MEMORANDUM

REVIEW TYPE: Preliminary Plan of Subdivision & Preliminary Water Quality Plan

PROJECT NAME: Bowie Mill Estates

CASE #: 120080160

Attachment B – Proposed Plan

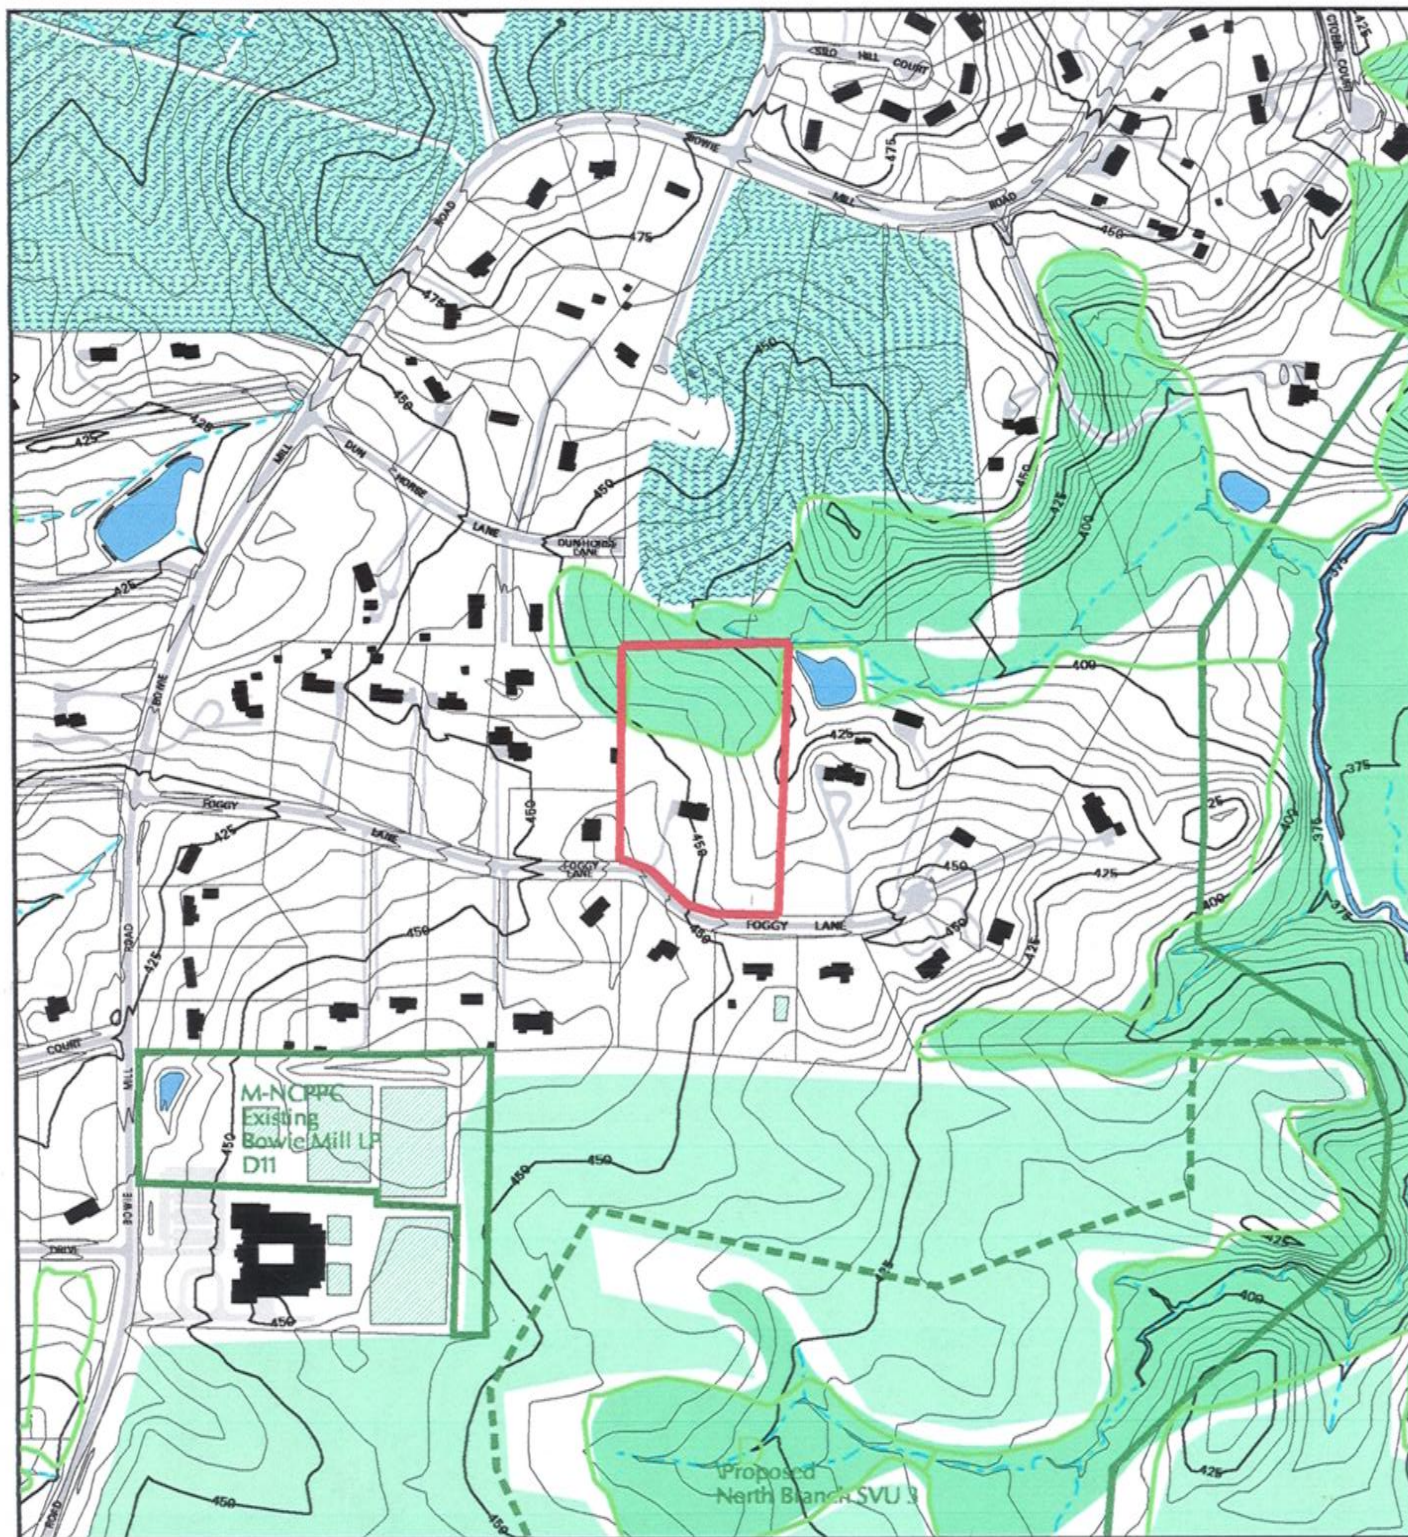
The applicant proposes to resubdivide the Subject Property and create 2 lots for 2 one-family detached dwelling units. Proposed lots 39 and 40 are each 4.64 acres in size. Proposed lot 40 is shown on the proposed plan as a pipestem lot served by a separate private driveway located not within the pipestem but near the western boundary line of lot 39. A 25-foot wide ingress/egress and utilities easement is proposed on lot 39 to accommodate the new driveway. The existing dwelling unit and driveway are to remain on lot 39. The lots are to be served by private wells and private standard septic systems.

- Dry wells and rooftop disconnect are required to treat stormwater runoff from rooftops.
- The proposed driveway for Lot 40 must be cross sloped to provide non-rooftop disconnection and vegetative filtering.
- A combination of dry wells, rooftop disconnect, sheetflow to forested areas, and non-
